SERVICE BULLETIN

No. 107 Date February 4, 1980

Subject: Modification Of Cabin Heater System For All Model Ercoupes, Aircoupes, and Fornaires Up To Serial No. 5699.

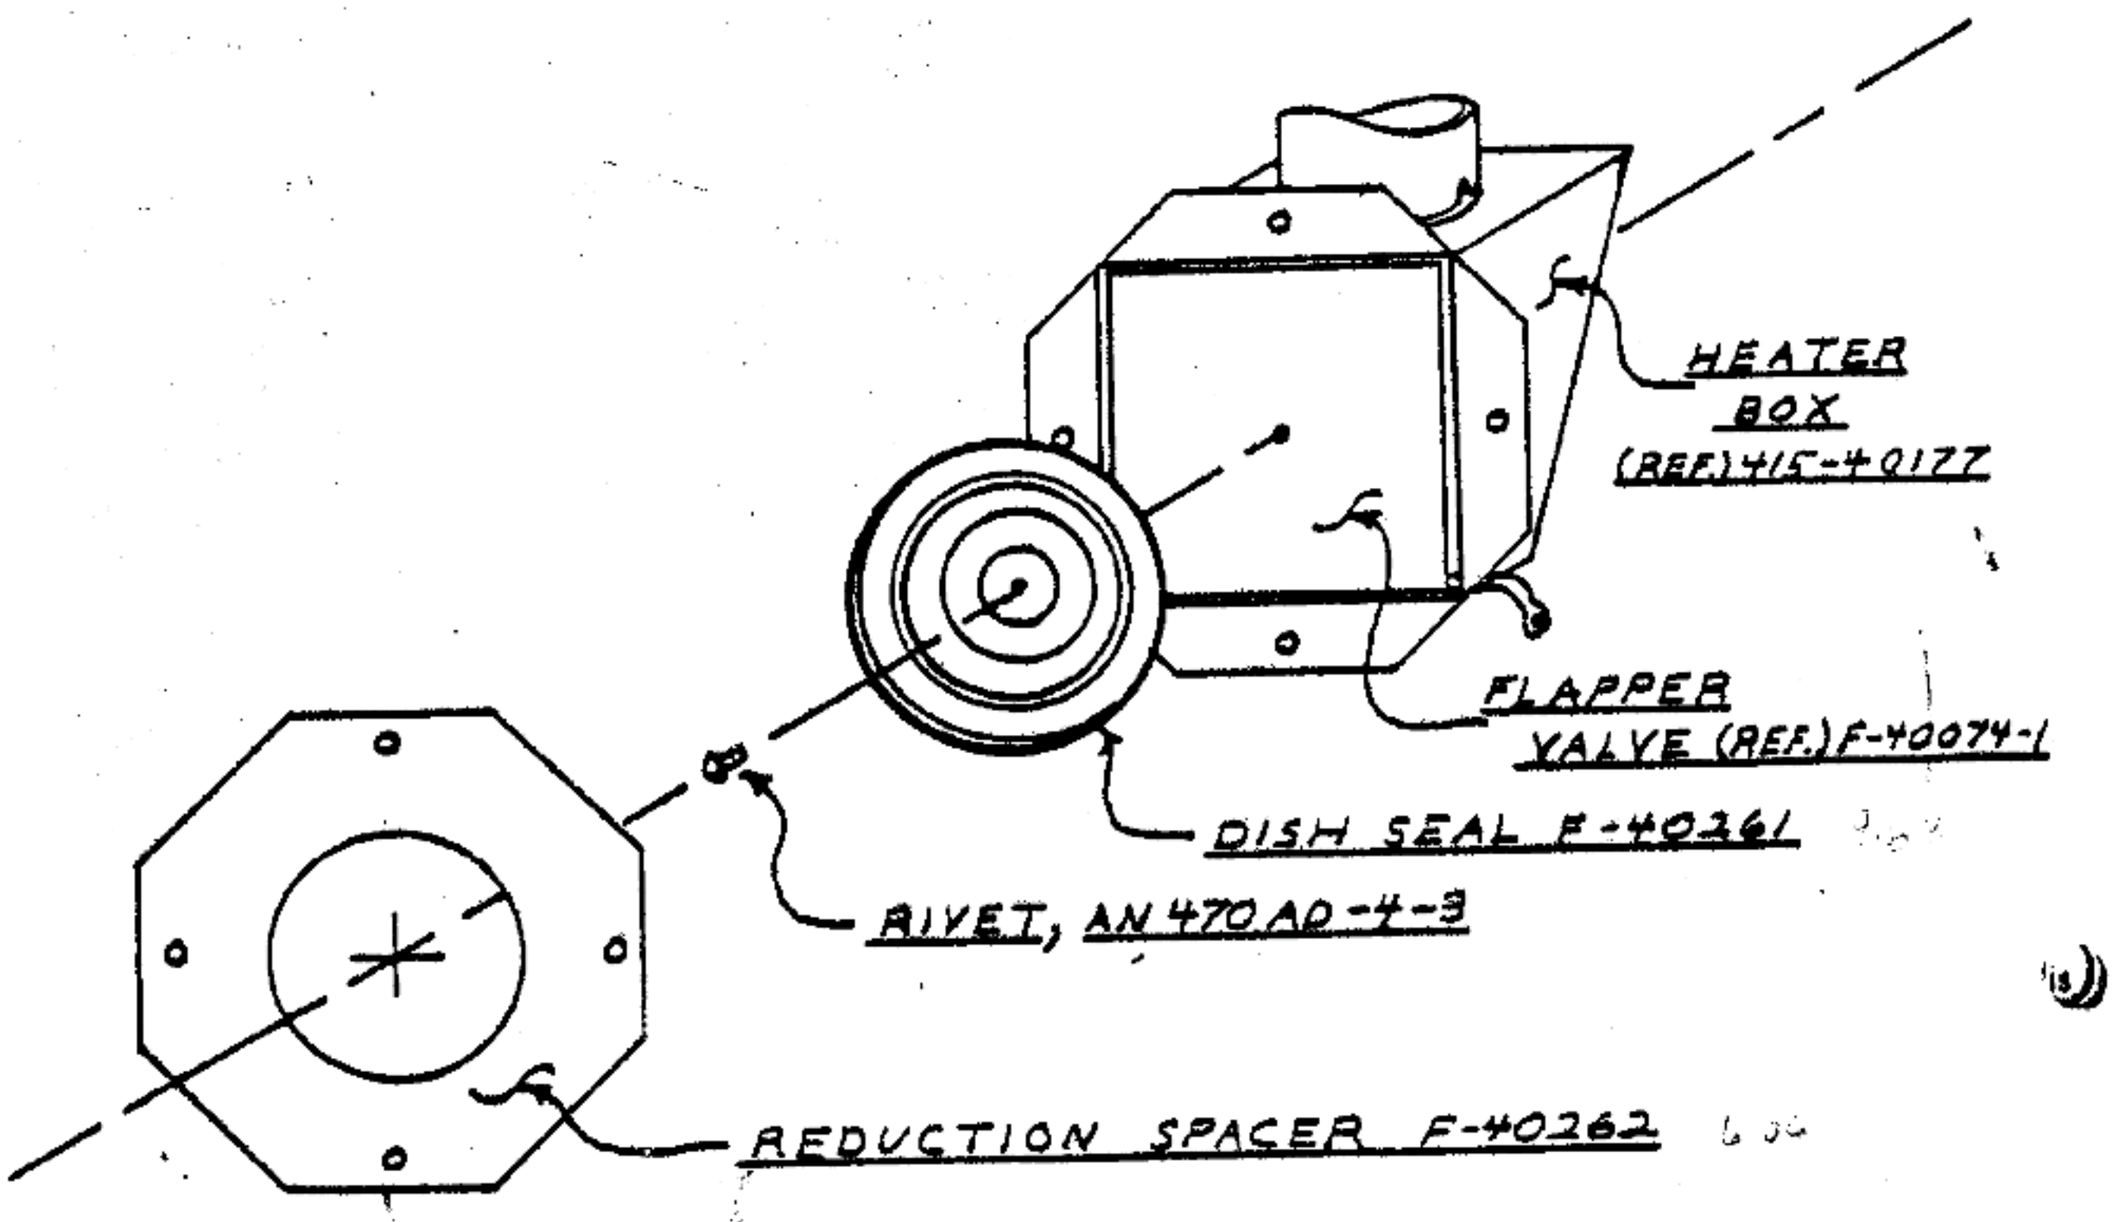
Problem:
It has been found that the flapper valve which controls the flow of cabin heat does not entirely seal to prevent hot air from entering the cabin section when it is closed. On hot days when cabin heat is not needed, there is enough leakage of hot air into the cabin section to make it uncomfortably warm.

Recommendation for Correction:
A "Dish Seal" has been designed that can be assembled on the present heater box which will entirely seal hot air from entering the cabin section. The accompanying figure shows the components of Forney Modification Kit #25 which consists of one each of:

Dish Seal	#F-40261
Reduction Spacer	#F-40262
Rivet	#AN470AD-4-3
Service - Installation Drawing	#F-40074

The Dish Seal is riveted to the center of the present flapper valve and the reduction spacer is inserted between the heater box and the forward side of the firewall. These components may be obtained by ordering the "Forney Modification Kit No. 25". This modification is inexpensive and for safety reasons we encourage airplane owners to make this correction. If an exhaust system failure would occur within the heater system during a flight, this modification would help prevent toxic carbon monoxide gas from entering the cabin section through the cabin heater box.
